关于 Dairi 铅锌矿矿区场地平整土石方工程施工  
招标文件第二次答疑

The second time clarification for tendering document of  
Dairi lead&zinc mine area site leveling earthwork and  
stonework construction

Bid No.: MC3-PC005-DPM-03-2019

例：1 块：such as:site 1

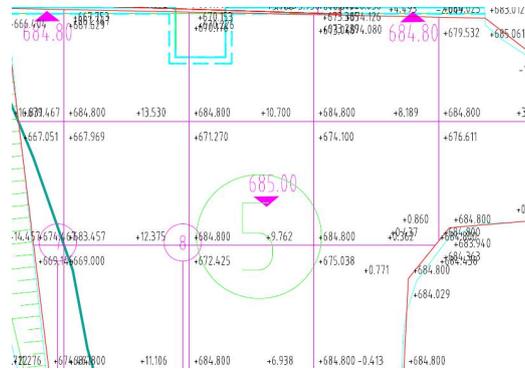
18、现有图纸中粉红色标高（594.5）是否为最终平整后的要求标高？如果是，是否与（595.5）的最终平整后的标高不一致？请明确

Is the pink elevation (594.5) in the existing drawings the required elevation after final leveling? If so, is it inconsistent with the final leveled elevation (595.5)? Please be clear.

个别地块不一致的情况如下/The inconsistencies of individual plots are as follows:

594.5 和 595.5 不一致/594.5 and 595.5 are inconsistent

回复：场地平整标高以方格网右上角标高为准。

Re: The elevation of the site is based on the elevation of the upper right corner of the grid.

例：5 块： /such as :site 5

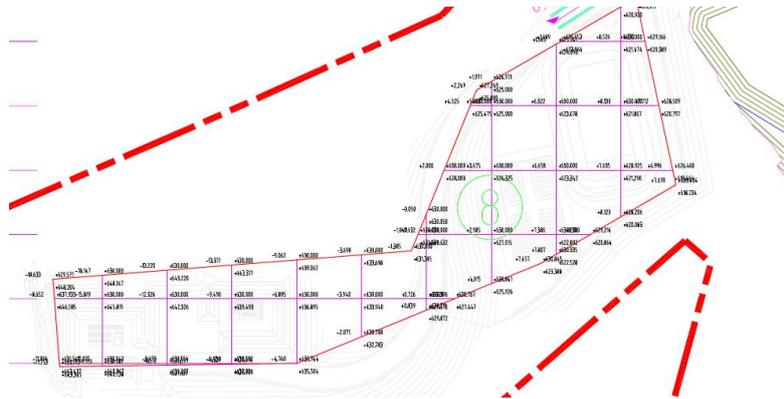
685 和 684.8 不一致/685 and 684.8 are inconsistent

例：8 块： /such as:site 8

没有标明平整后的顶部高程/No flattened top elevation is indicated.
